Garden City Design Review Application Review

DSRFY2025-0004 Mariposa Labs

Review Date: **2-25-25**

Figure 8-4C-5

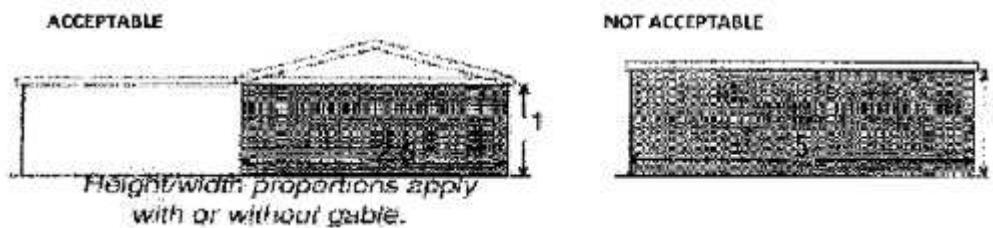
- a. Pre-fabricated buildings are prohibited.
- b. Are the 6 panel windows with a 5'-6" sill actually windows?
- c. No new chain link fence shall be added.
- d. 8-4C-3:A7 Wall Plane: Facades should have no wall plane wider than two and one-half (2 1/2) times the height of the wall plane. If a new wall plane is required to achieve compliance with this requirement, it must be offset by at least six feet (6').
